# ADDENDUM SHEET

Project: Los Osos Valley Road/U.S. 101 Interchange Improvements Project  
EA: 05-0H7300  
Location: 05-SLO-101 (PM 25.5/26.3)

The following corrections are made to the *Scenic Resources Evaluation, Los Osos Valley Road/US 101 Interchange Improvements Project, City of San Luis Obispo, California* (November 2006).

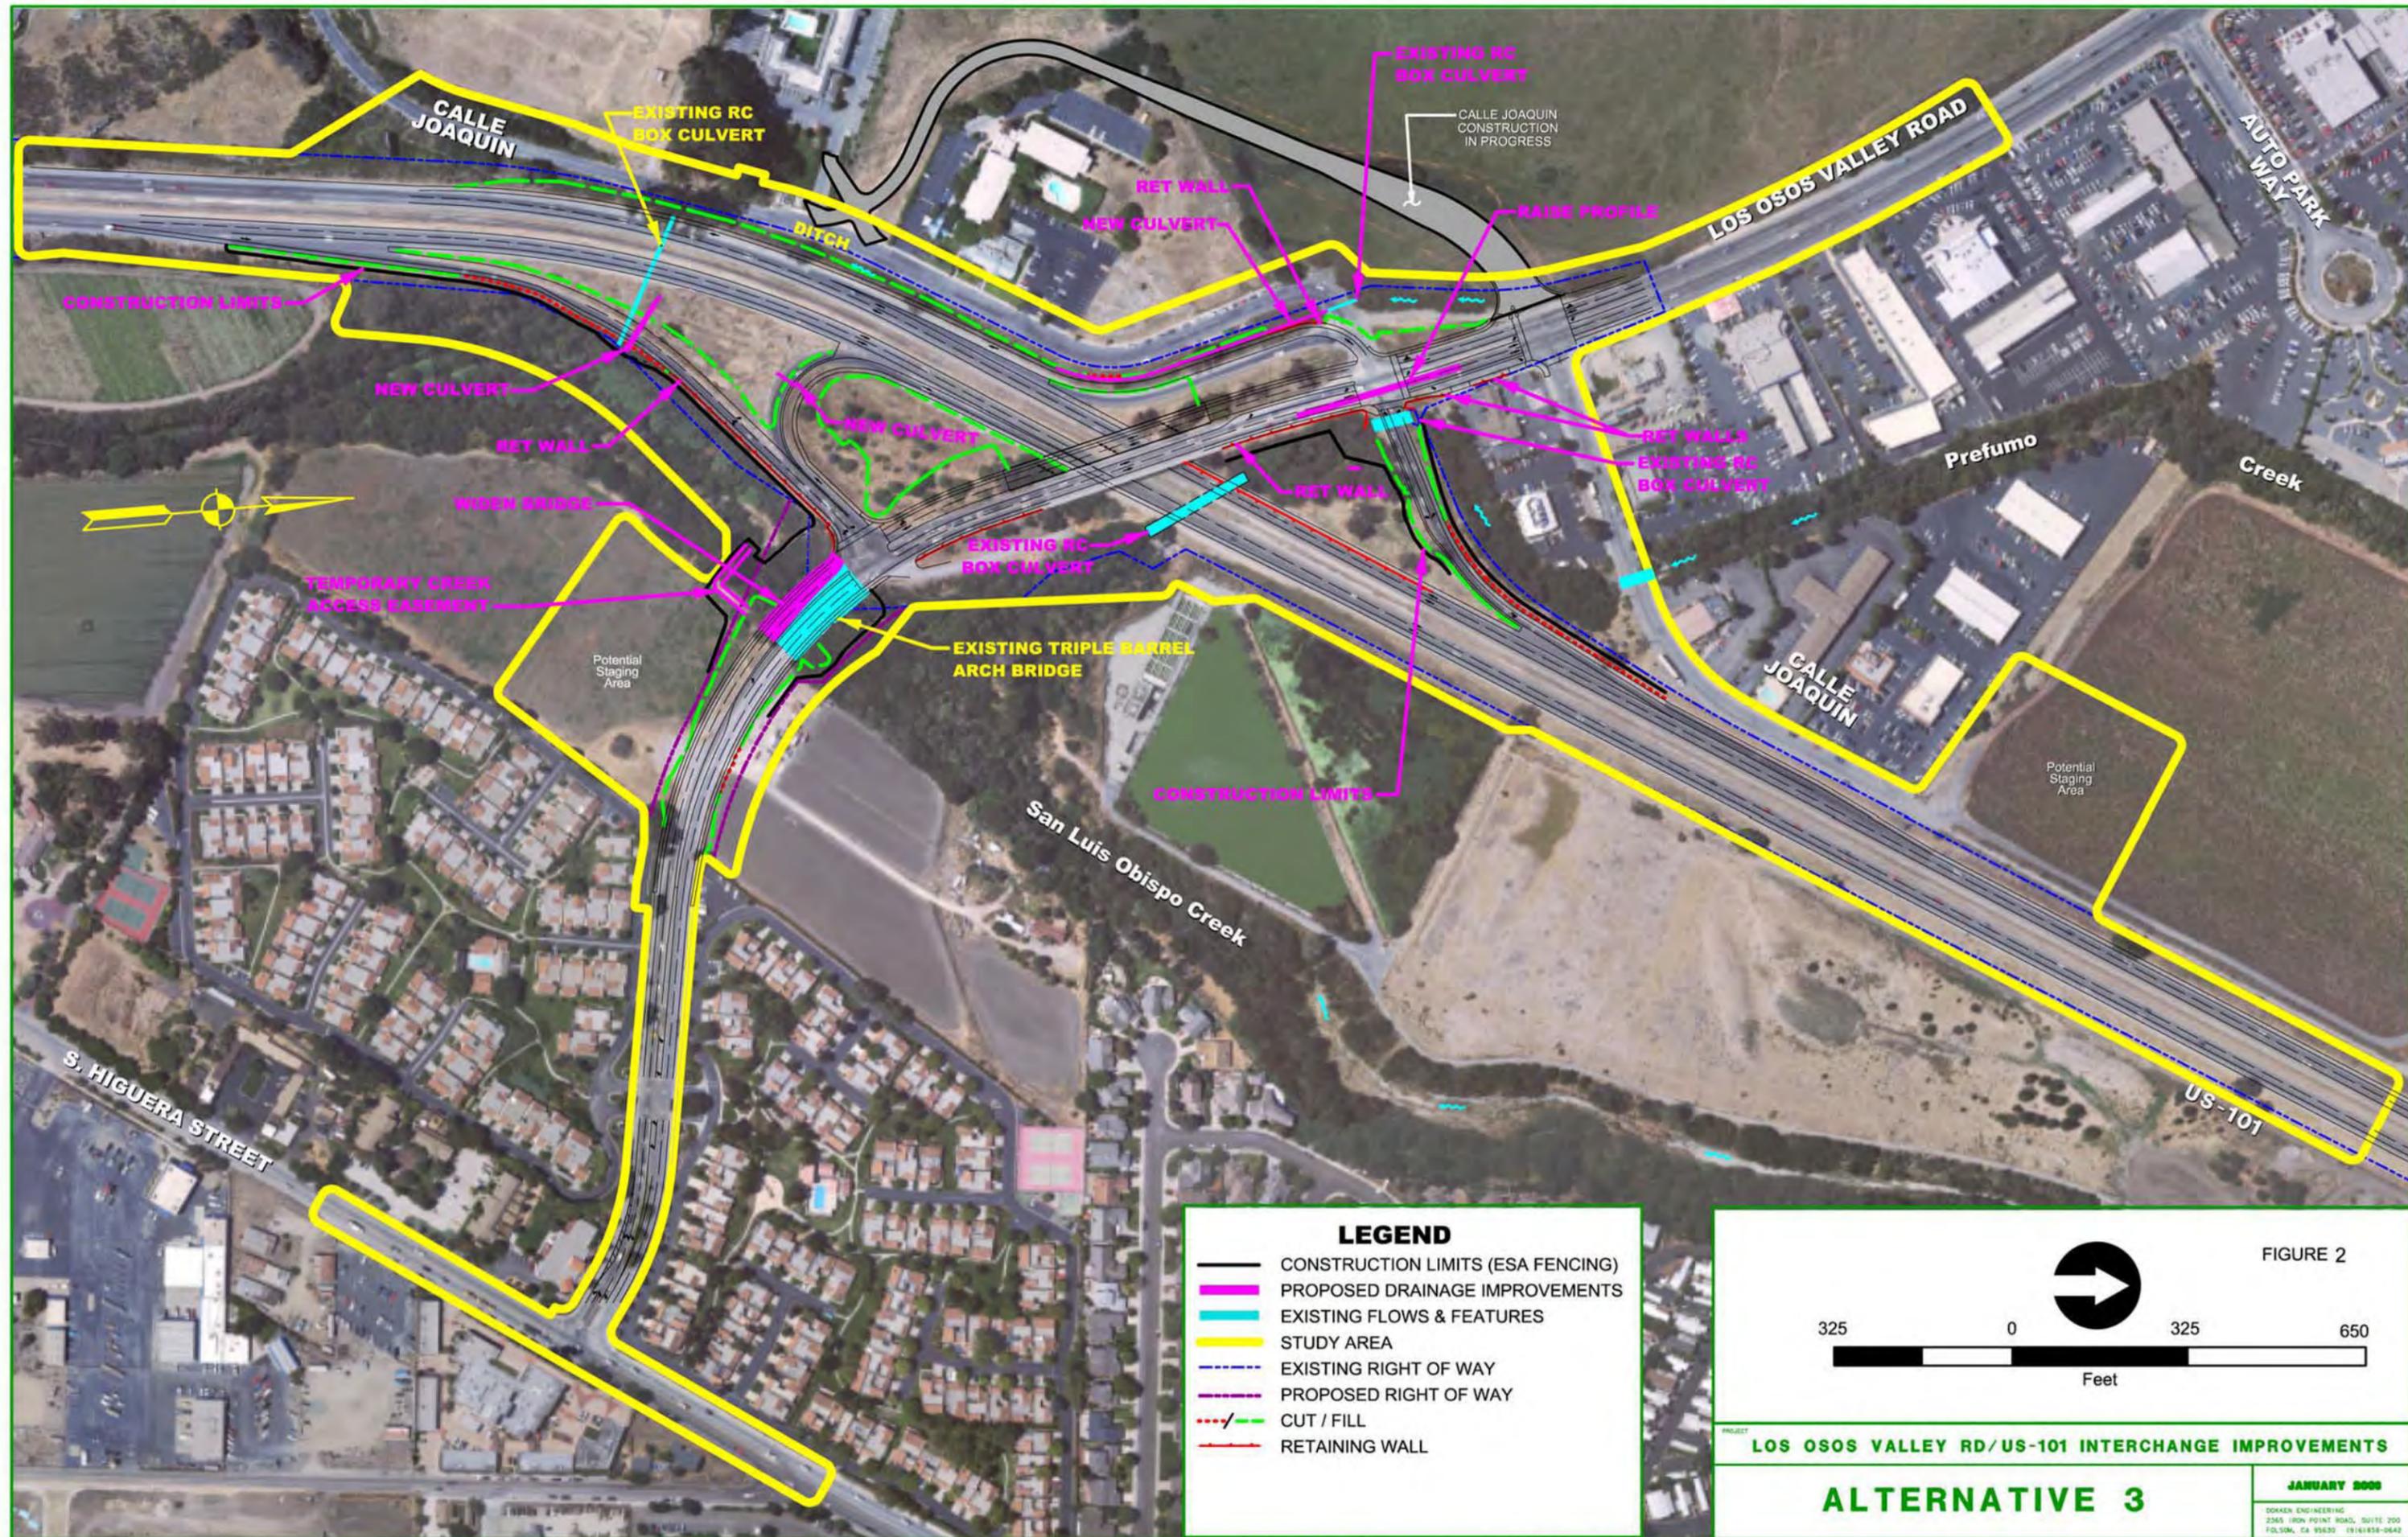
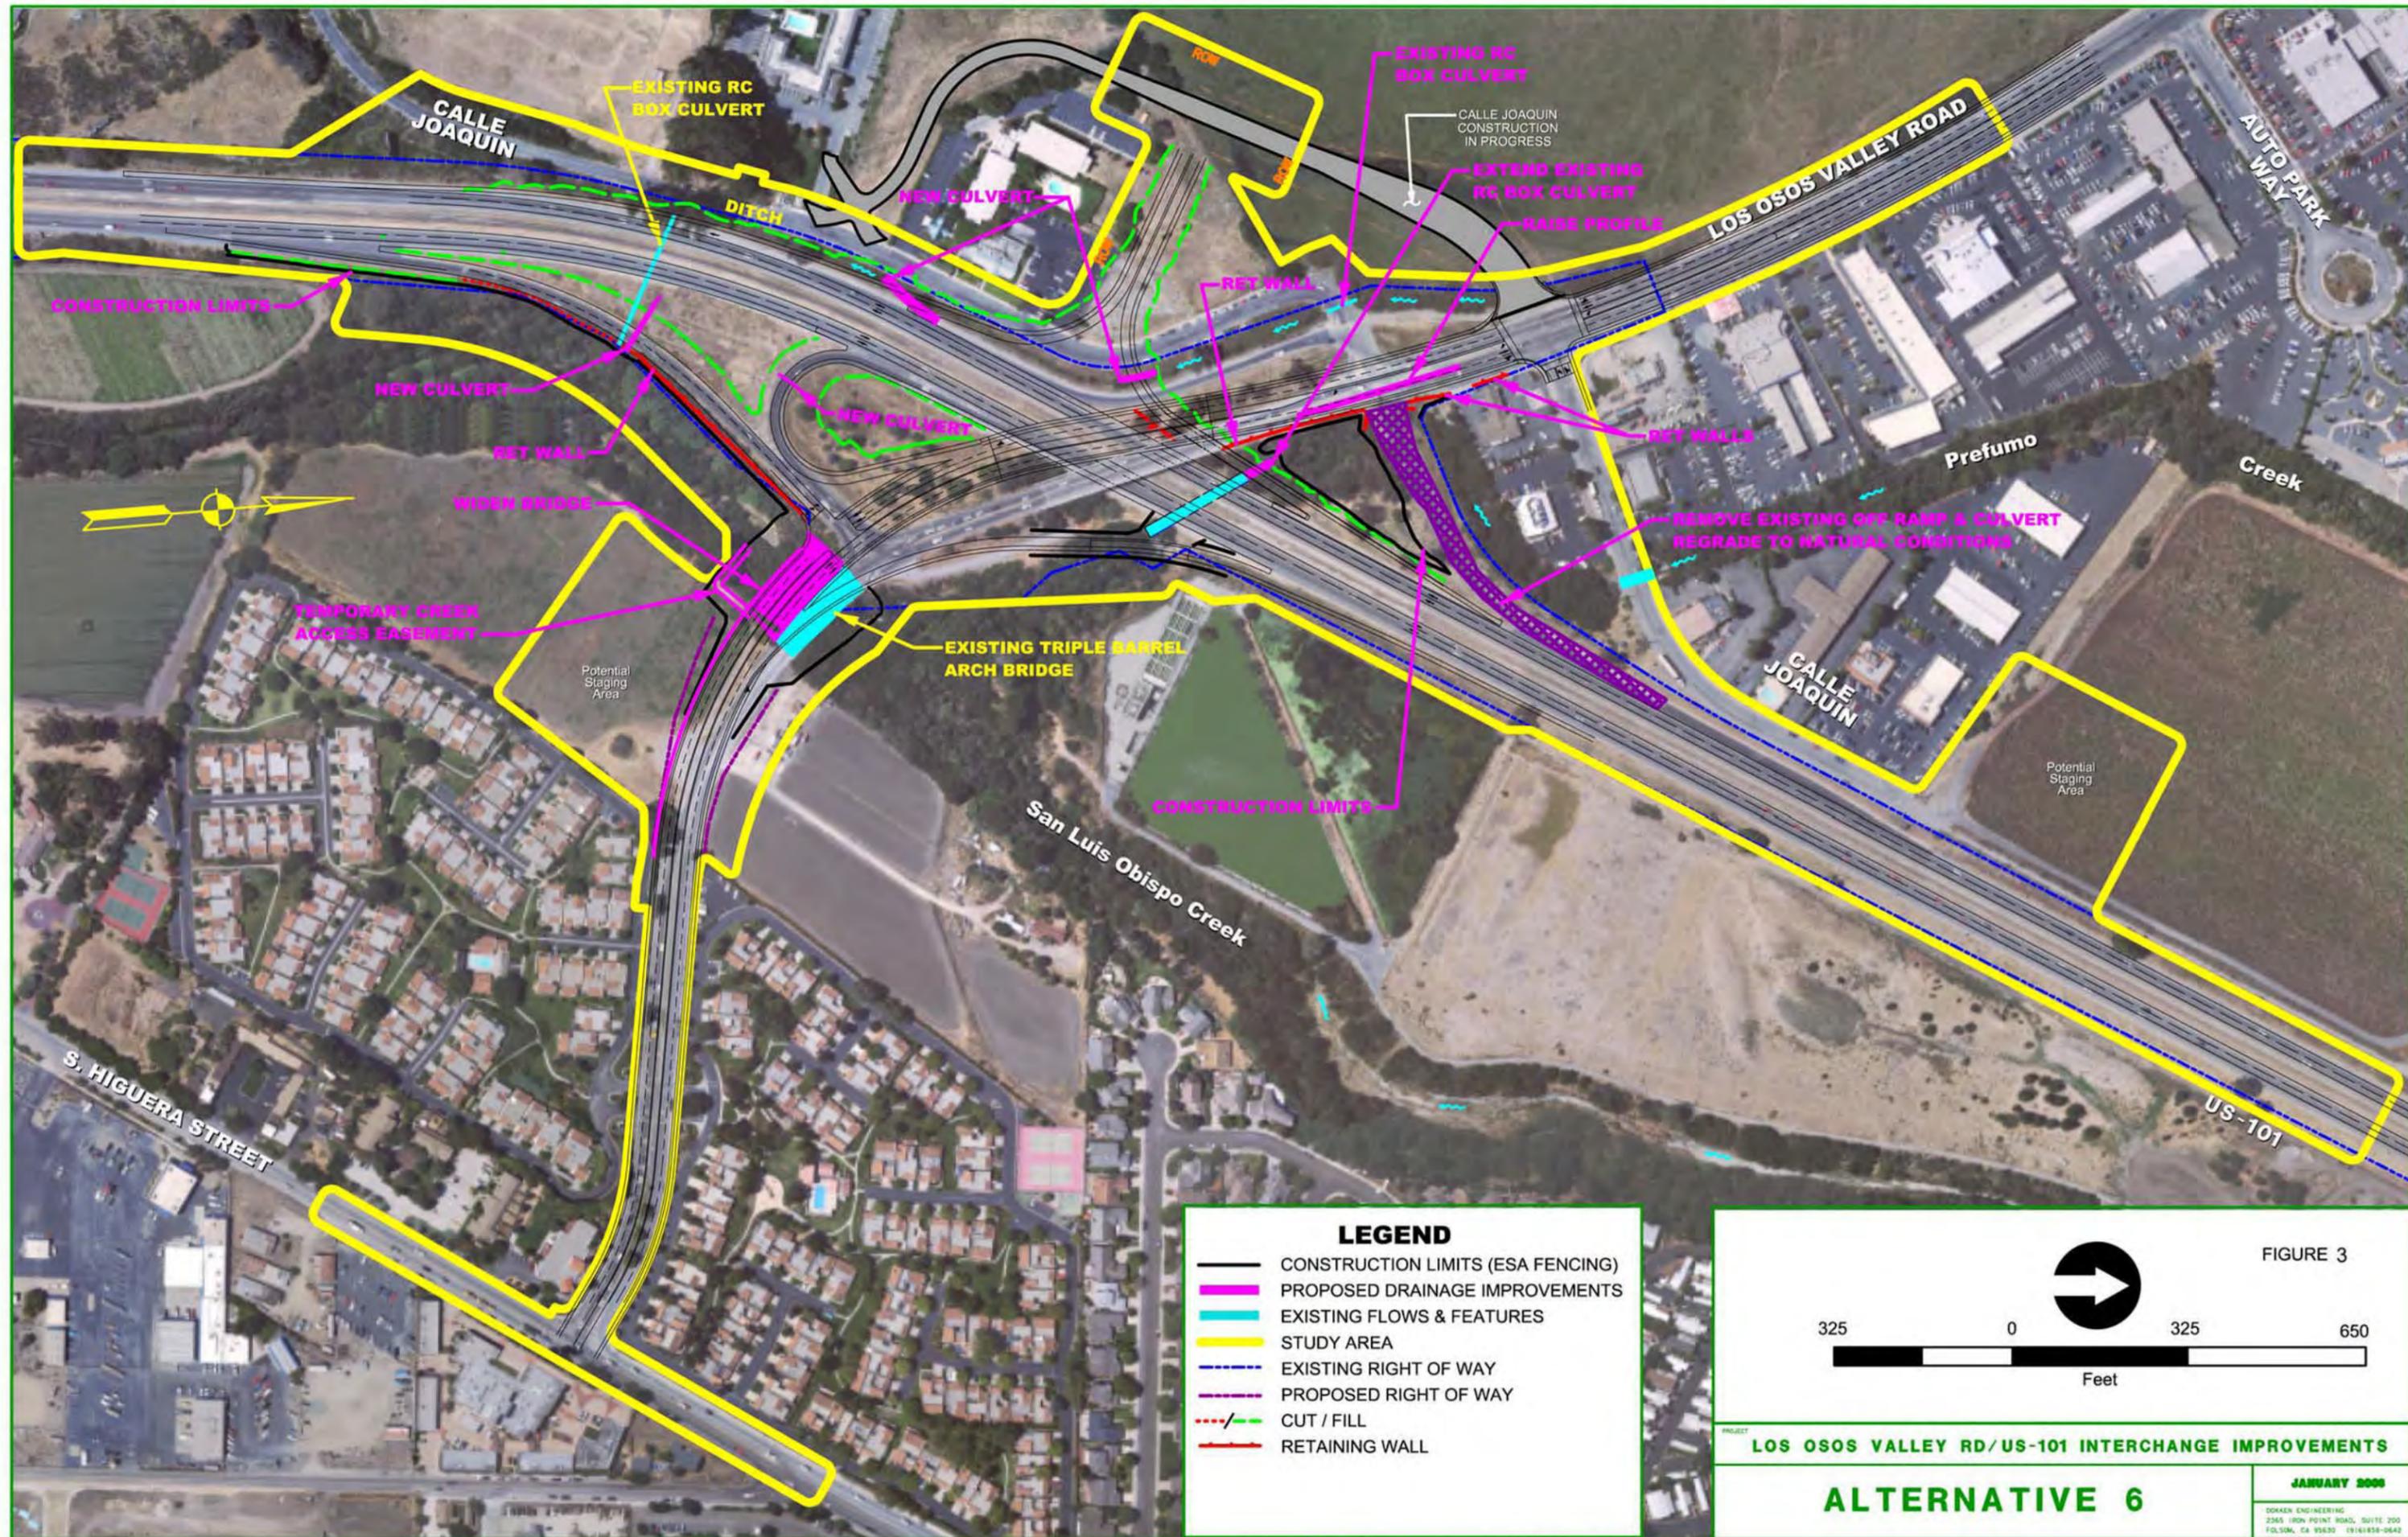
Section/Page	Change From	Change To
Project Description; Page: 5	Project description is brief and does not include discussion of the 7' Prefumo Creek culvert under US 101	Complete project description has been included for clarity of all project components
Figure 2 (Alternative 3) and Figure 3 (Alternative 6)	Locations of the proposed 7' Prefumo Creek culvert under US 101.	All indications of the proposed 7' Prefumo Creek culvert under US 101 were eliminated see attached Figures 2 and 3.

No changes result from the changes in the project, therefore, the analysis in the *Scenic Resources Evaluation for the Los Osos Valley Road/US 101 Interchange Improvements Project, City of San Luis Obispo, California* (November 2006) remains valid.
